AIRFIELD & TERMINAL MODERNIZATION PROJECT

LOS ANGELES INTERNATIONAL AIRPORT (LAX)

FINAL ENVIRONMENTAL IMPACT REPORT (FINAL EIR)

Main Text

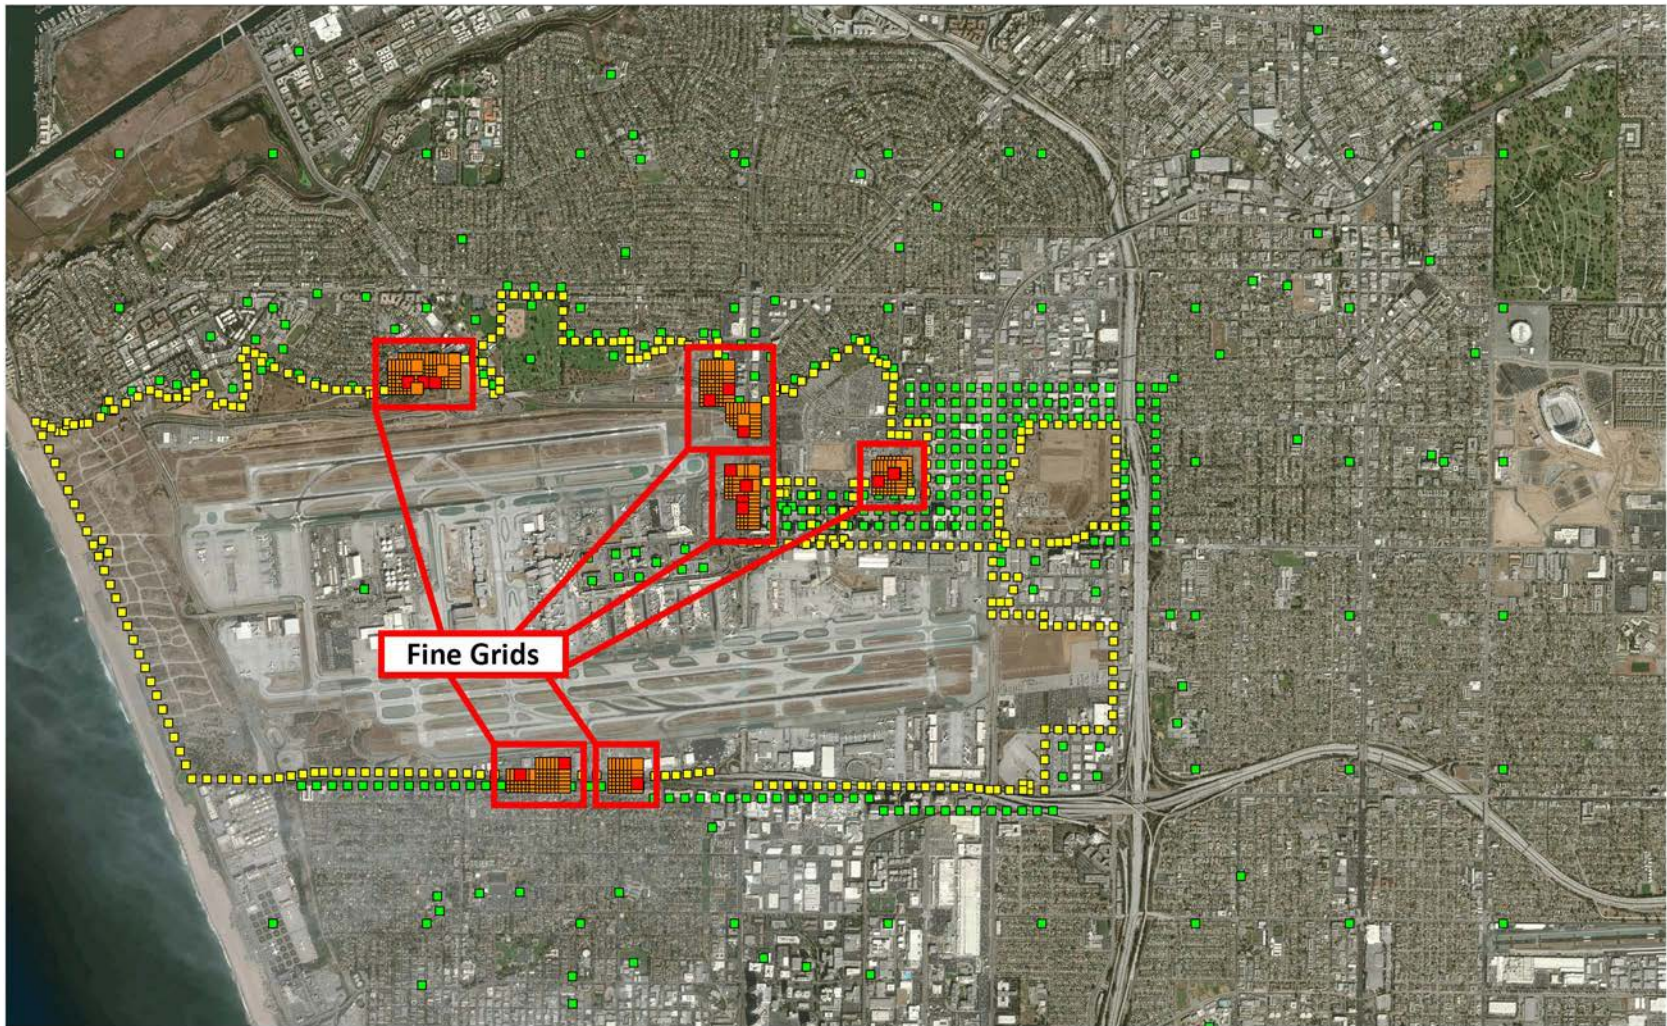
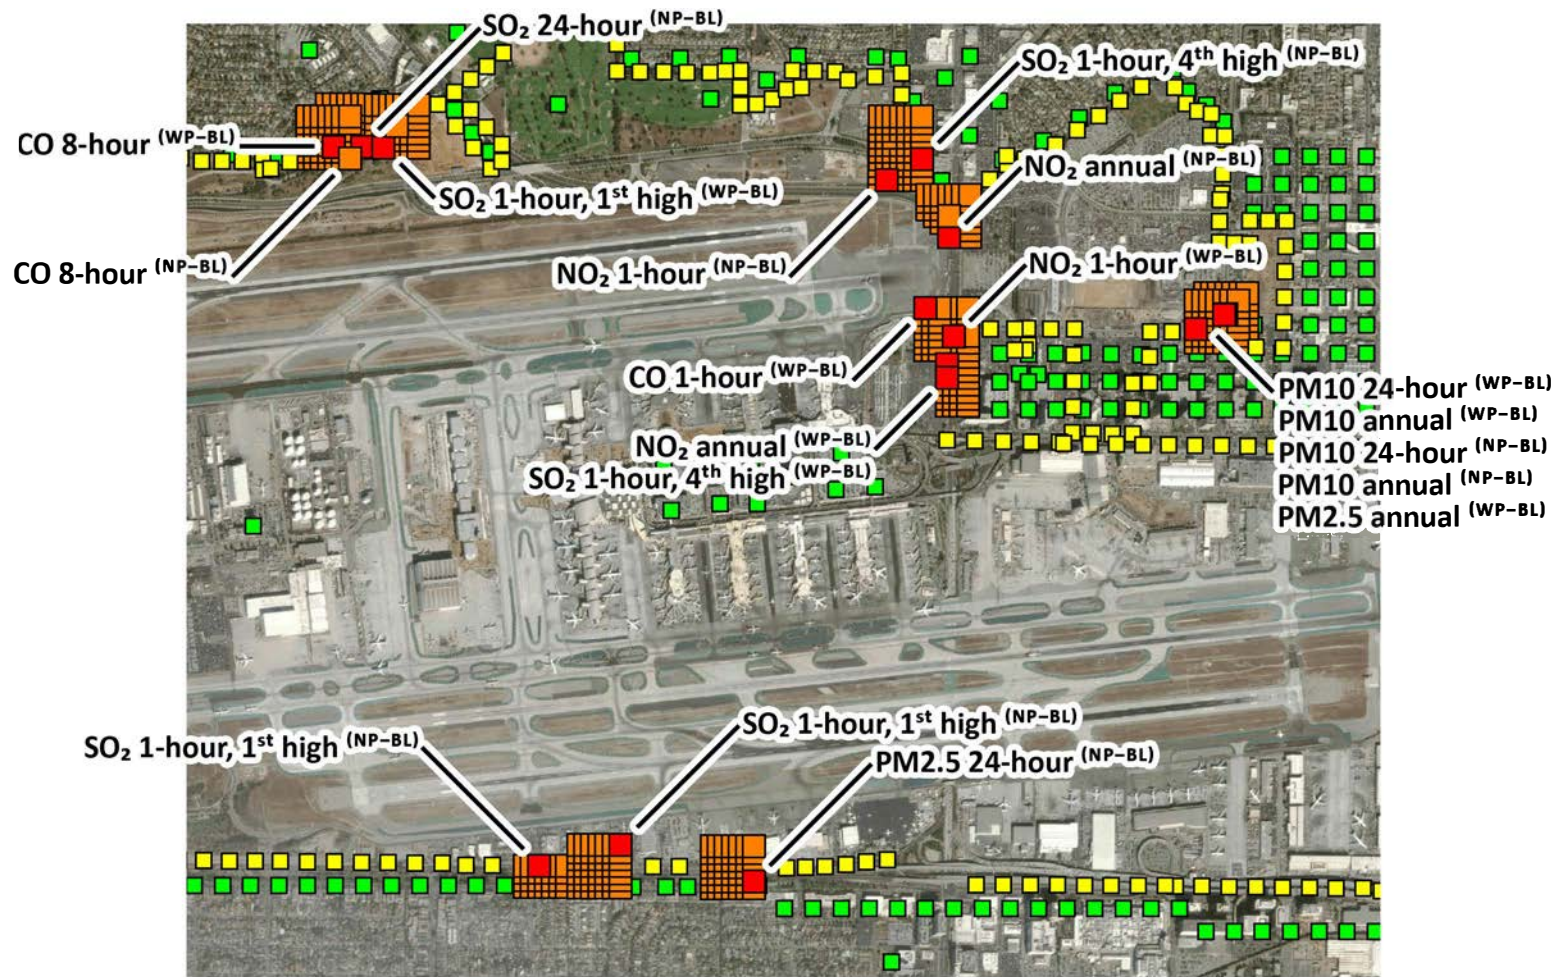
Comment: 2. Air Dispersion Modeling Parameter

To analyze the Proposed Project's localized air quality impacts and HRA, the Draft EIR performs project-specific air dispersion modeling. The Draft EIR states that sensitive receptor locations were determined in a manner that would identify peak ambient air pollutant impacts associated with the Proposed Project[16]. The Draft EIR also states that initial off-site sensitive receptors will have a 100-meter spacing, and that refined sensitive receptors will be placed immediately around the initial impact location using a 25-meter spacing to verify the ultimate peak concentrations have been identified[17]. Based on a review of the air dispersion modeling files, South Coast AQMD staff found that sensitive receptors are placed at the fence line with a 100-meter spacing, that a uniform Cartesian receptor grid with a spacing of 100 meters is used to the northeast of the LAX property boundary over the rental car facility, and that various discrete receptors are placed beyond the LAX property boundary (see Figure 1). The receptor grid that is placed to the northeast of the LAX property boundary might not have been large enough to identify the maximum off-site concentrations. Therefore, South Coast AQMD staff recommends that the Final EIR provide additional information to justify the receptor grid used or perform additional modeling with an expanded receptor grid.

As shown in Figure 1, peak impacts identified with the base receptor set were located along the airport fence-line, with the exception of particulate matter impacts, which were located near the future Intermodal Transportation Facility – West (ITF West) being constructed as part of the LAX Landside Access Modernization Program. Figure 2 of this response identifies the locations of fine grid areas and the associated pollutants analyzed for each area. The particulate matter (PM10 and PM2.5) peak impact location

would be dominated by paved road dust from vehicle traffic going to and from the ITF West, which is under construction. The incremental change in PM10 and PM2.5 between 2028 with the proposed Project and the 2018 Baseline is due primarily to the increase in vehicle miles traveled (VMT) between 2018 and 2028. In general, the other fine grid locations address the various gaseous pollutant peaks. These are generally dominated by aircraft activity on the airfield and are located on and next to the fence-line around LAX.

Refinements to Landside Access Modernization Program (LAMP) Roadway System that are Reflected in the Airside and Terminal Modernization Project Roadway System

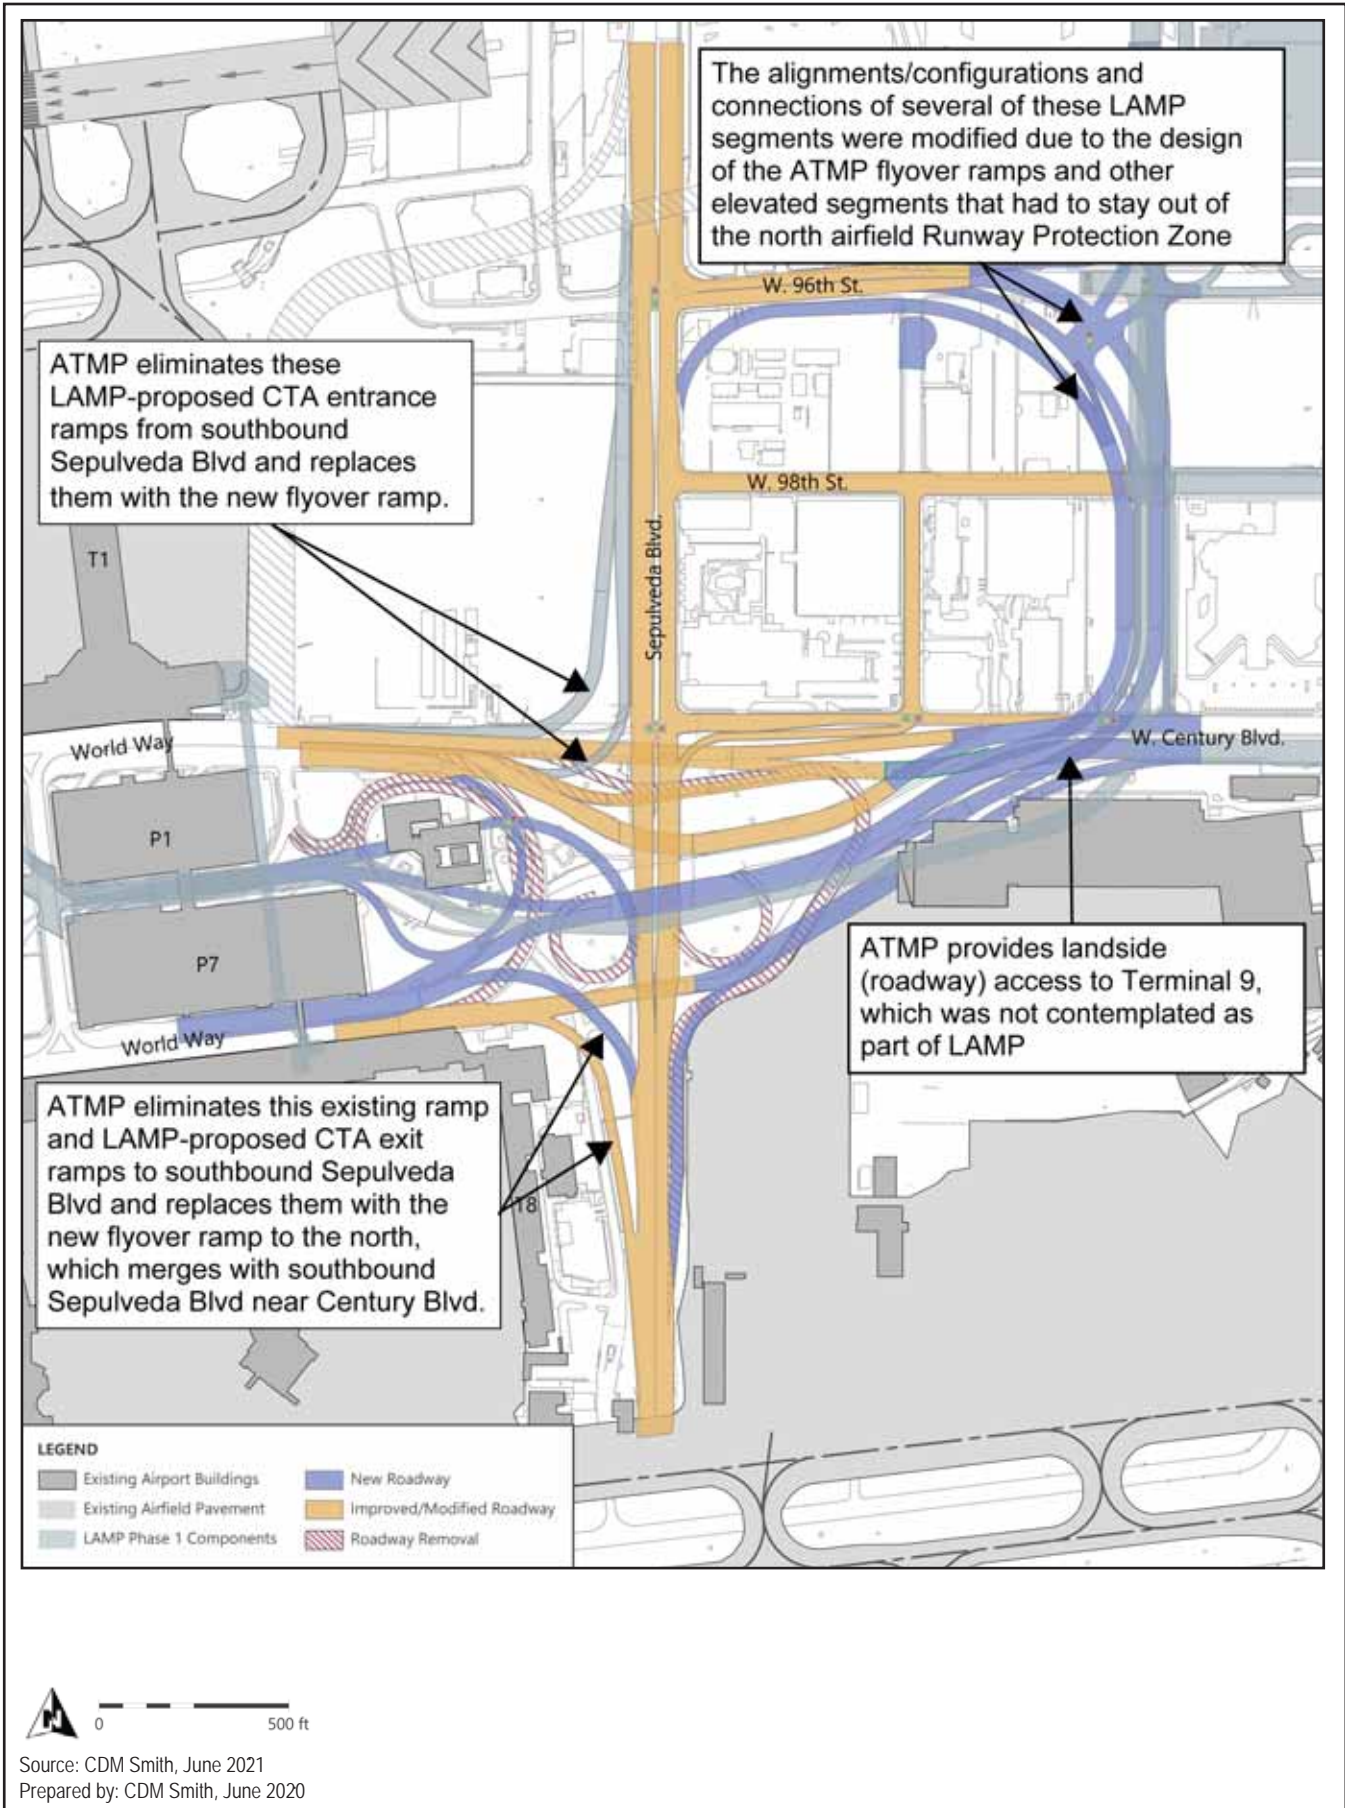
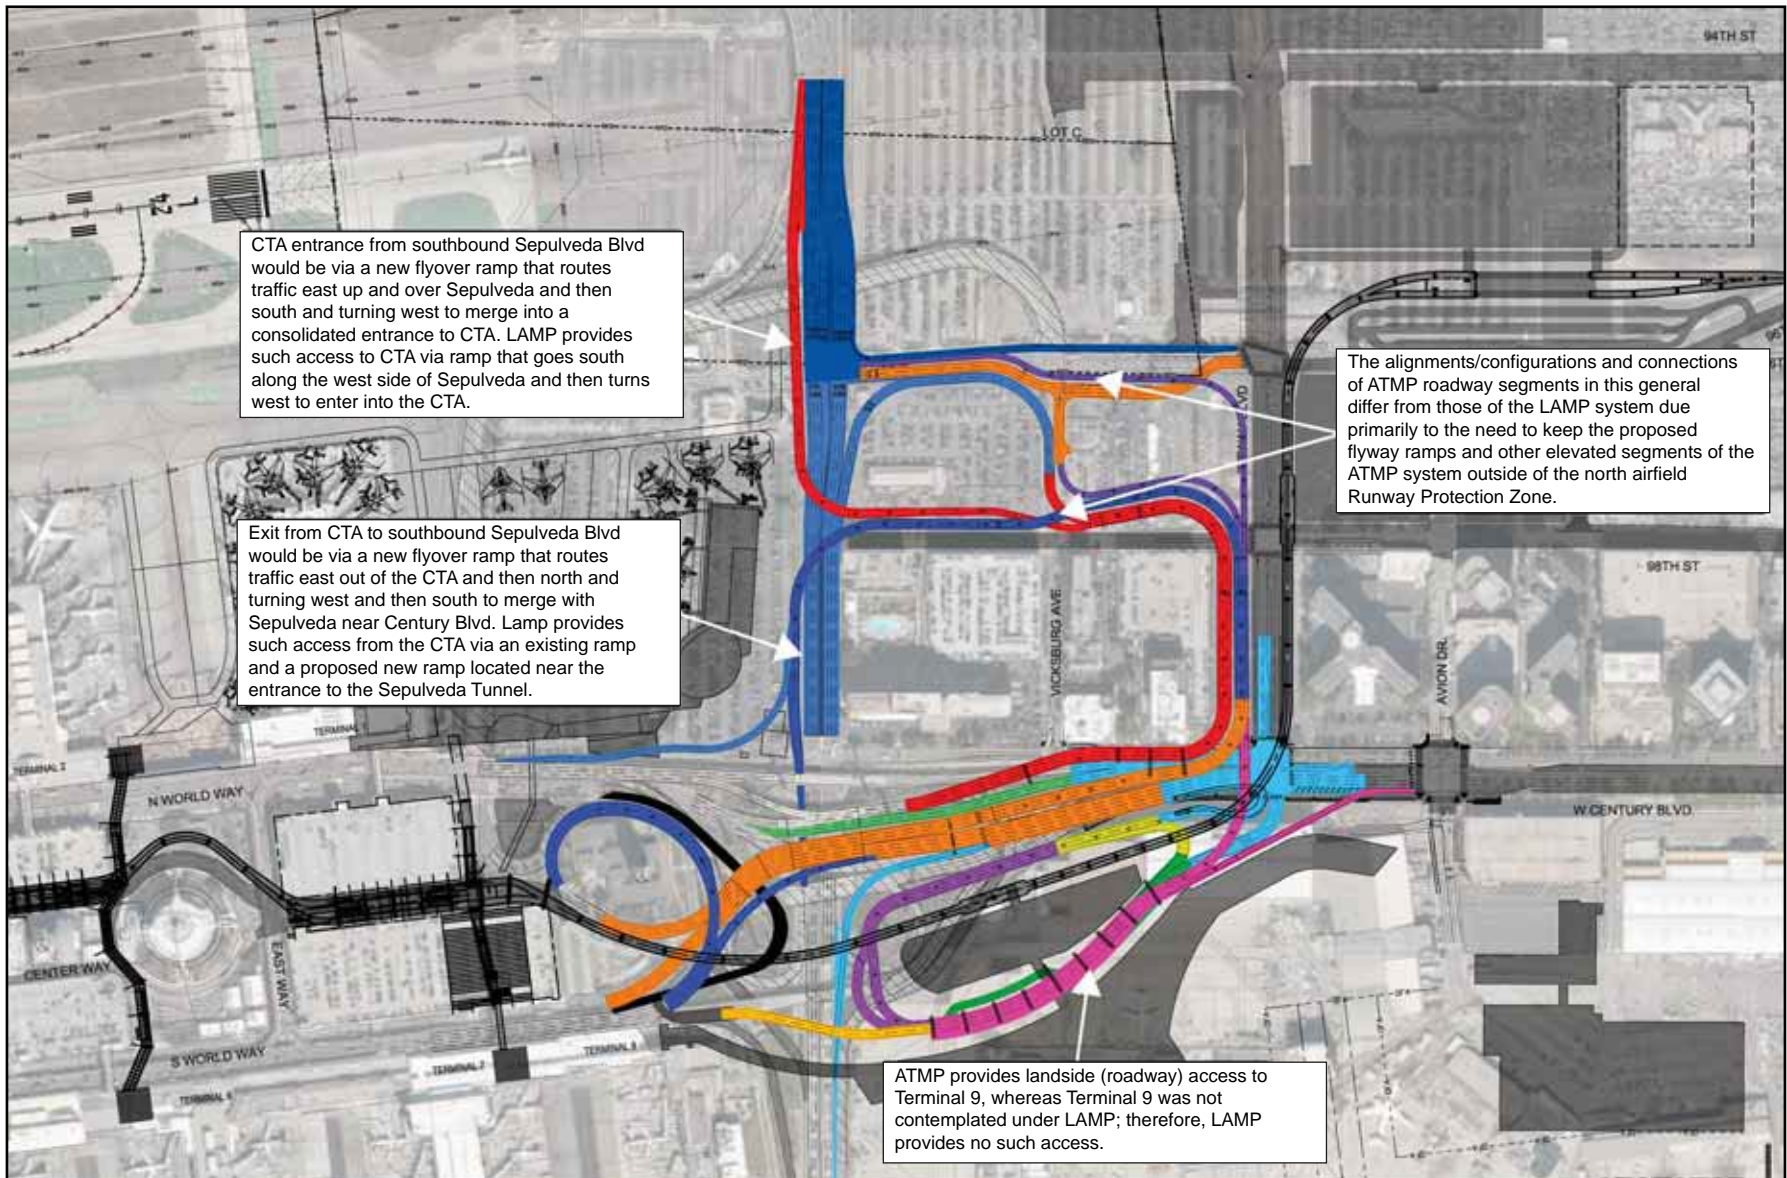
The Project Description omits important details relating to the Project’s surface transportation system. In particular, the DEIR states that the project “. . . would build upon improvements approved as part of the LAX Landside Access Modernization Program [LAMP] . . .” DEIR at p. 2-39. The DEIR also refers to “refinements” to the LAMP road system, with the proposed Project’s improvements being “integrated with” the LAMP elements. The document does not, however, specifically identify which, if any, LAMP projects would be eliminated or significantly modified as a result of the proposed Project. The EIR should be revised to identify the specific changes to the LAMP road system that will be undertaken in connection with the ATMP. The revised EIR should also include graphics showing this information.

Response: The refinements to the LAX Landside Access Modernization Program’s roadway system that are associated with the LAX Airfield and Terminal Modernization Project pertain to the area immediately east of the Central Terminal Area (CTA). Figure 1 shows the roadway system approved for that area under the LAX Landside Access Modernization Program and Figure 2 shows the proposed roadway system associated with the proposed Project, along with the automated people mover (APM) station proposed in conjunction with Terminal 9. The following summarizes the key refinements to the LAX Landside Access Modernization Program’s roadway system:
